CITY COUNCIL ACTION FORM

Ordinance 2022-21 - First reading and setting the Public Hearing for the 505 Oak Street Major Impact Review application for a Planned Development Overlay and Major Subdivision of the property located at 505 Oak Street.

RE: 505 Oak Street Major Impact Review and Planned Development Engineering Comments
JVA Job# 3121.17c

PRELIMINARY SUBDIVISION PLAT

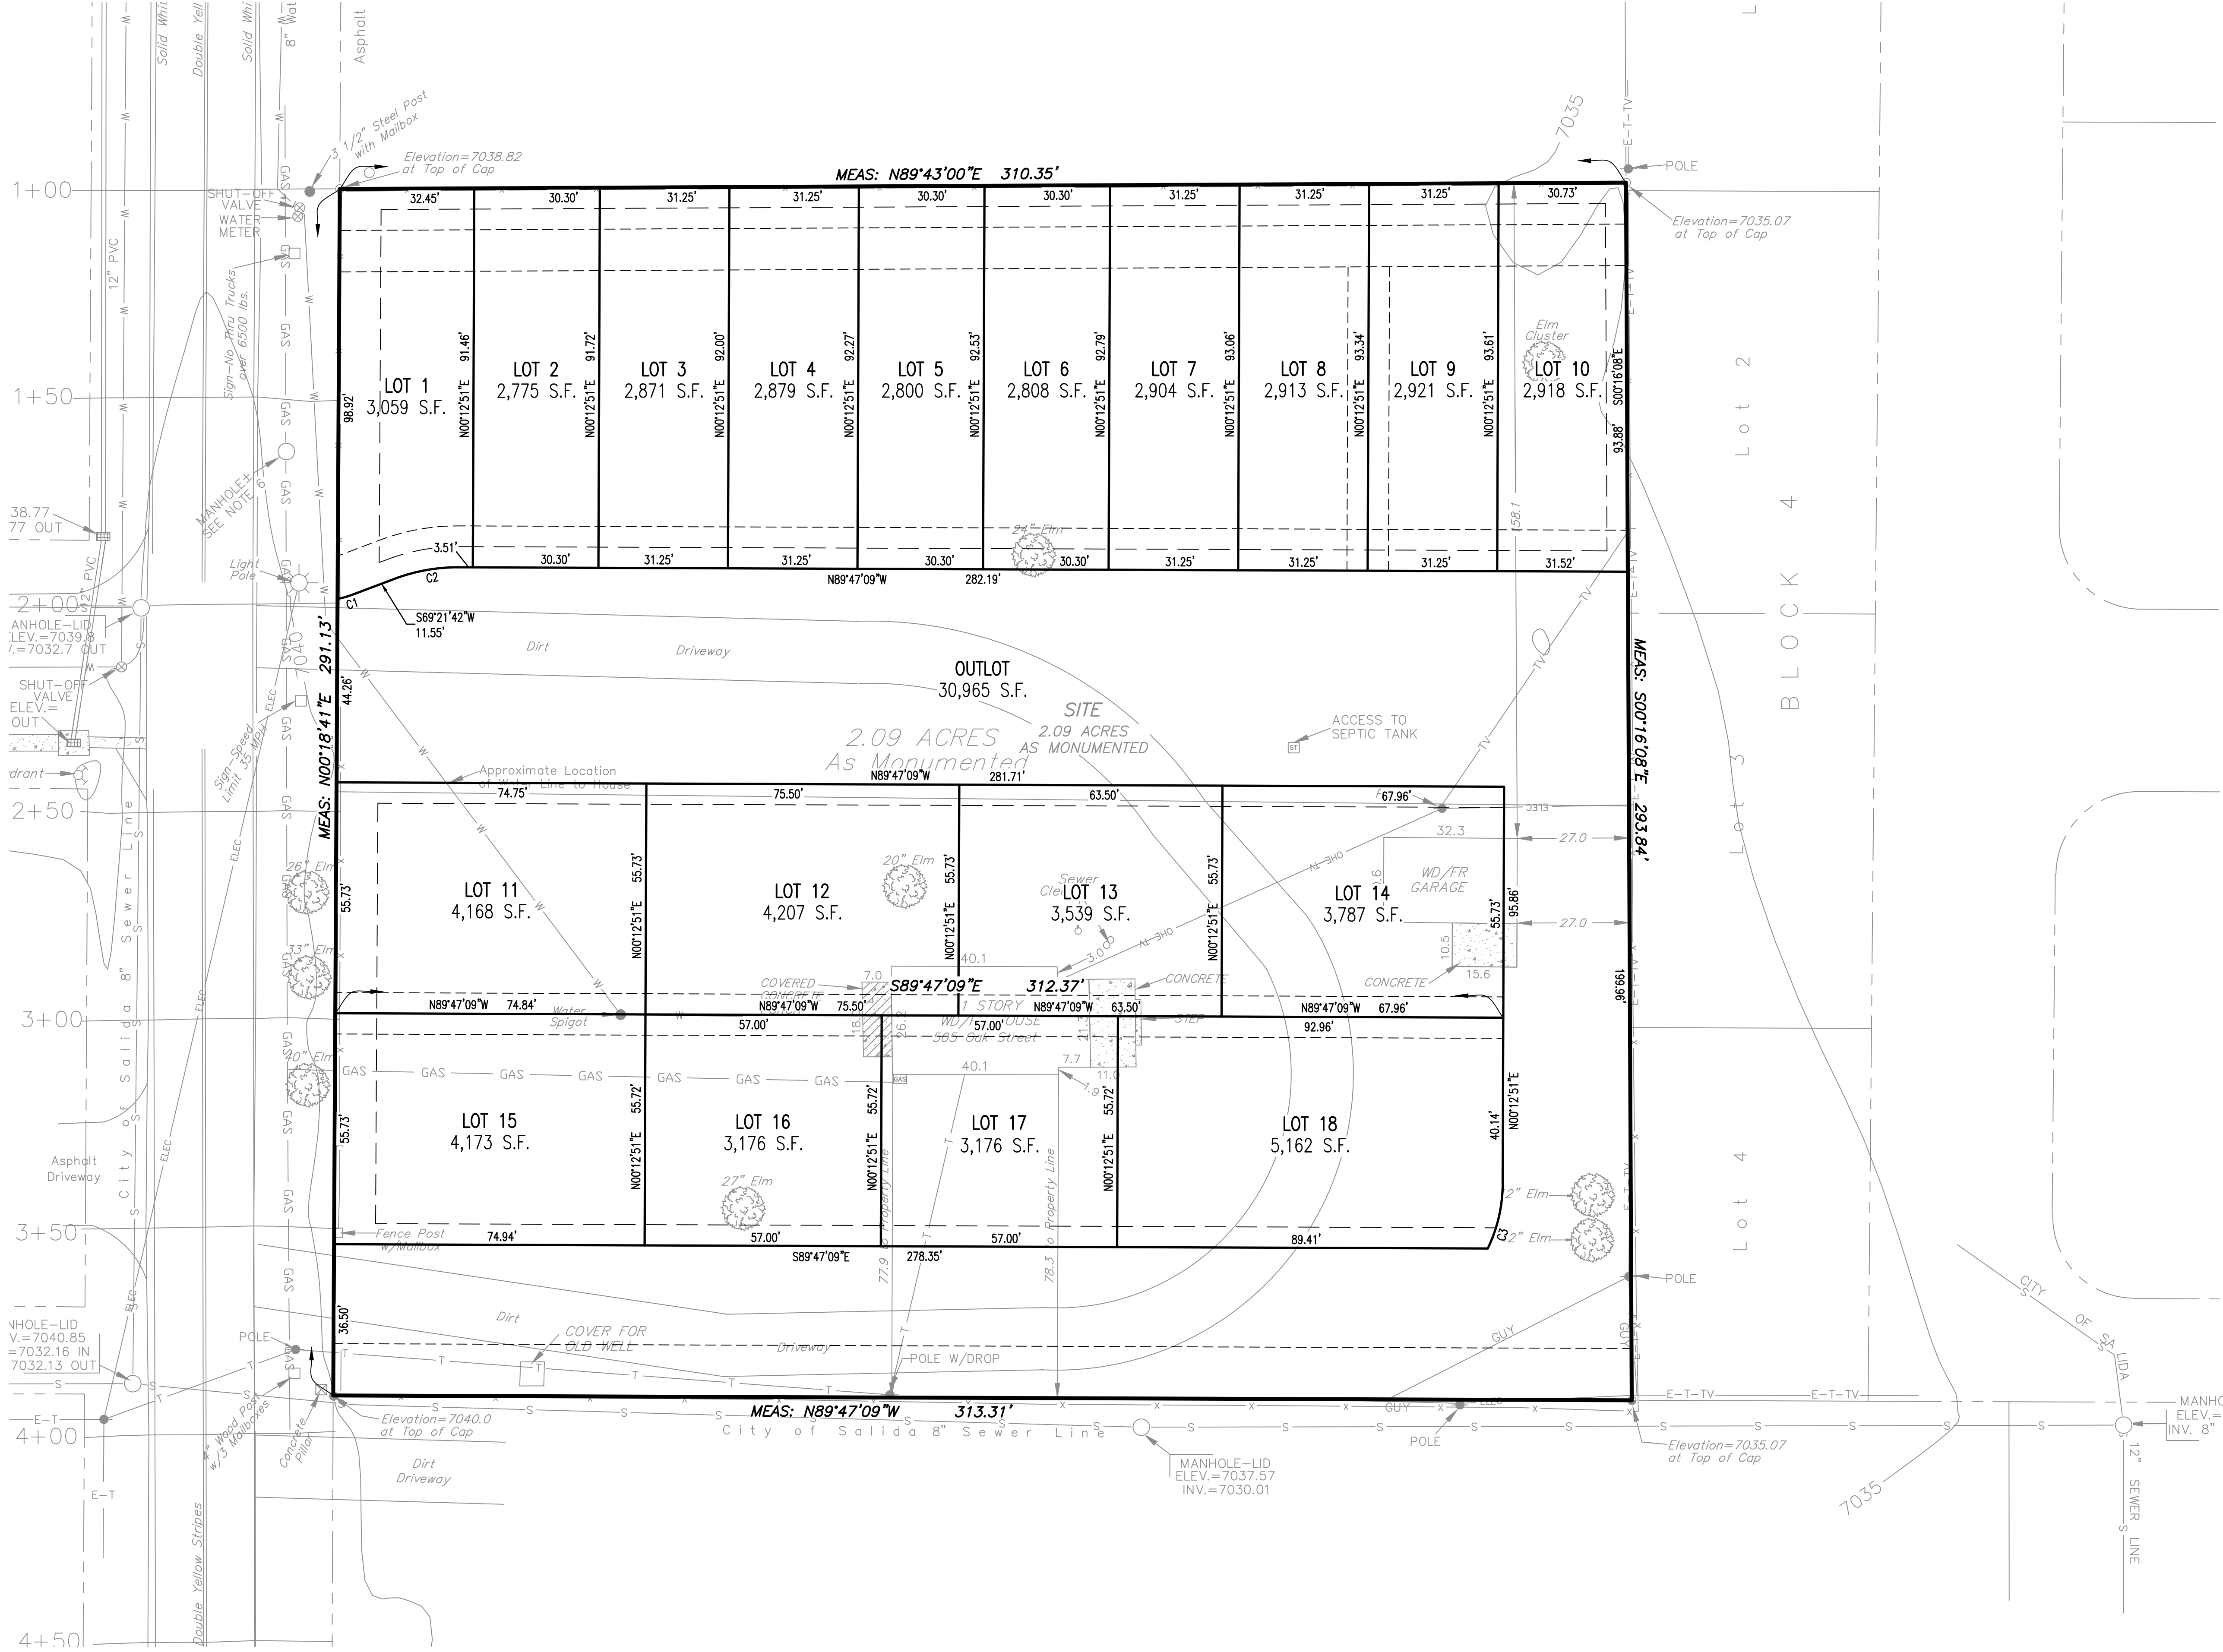
The private road is shown on the plat as an out-lot. This is not considered an “out-lot” but a private road. The plat will need to be updated to remove “out-lot” and have the private road named.

3. A name for the private road be added to the plat and “out-lot” removed.
4. Prior to issuance of any Certificate of Occupancy for units within the subdivision the applicant shall pay a fee in lieu of providing the Oak Street Streetscape improvements in an amount determined by the Public Works Director.

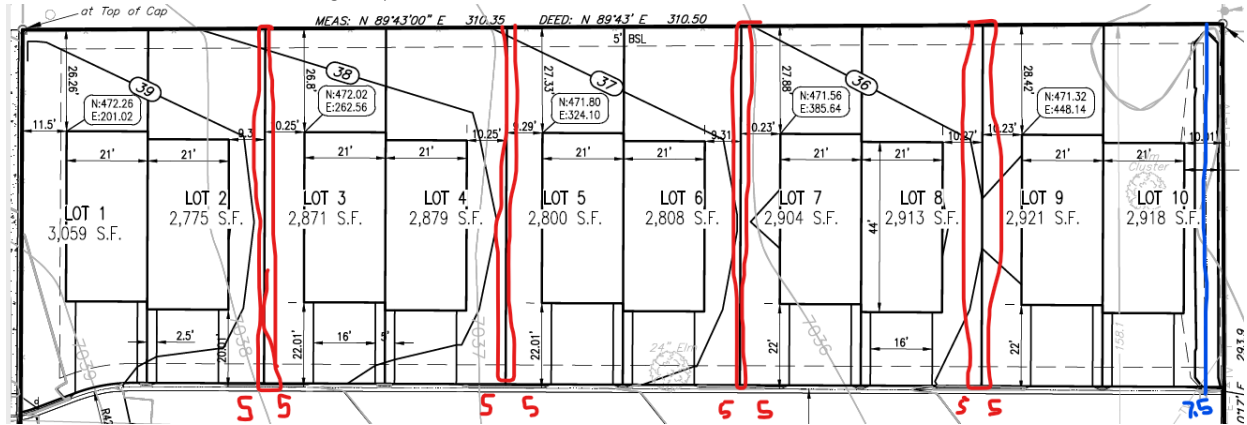
5' rear lot easements on all rear lots

Lots 11-18 5' side lot easements. For side easements see below for lot 1-10

Customer to relocate or remove existing utility lines into easements at their cost.
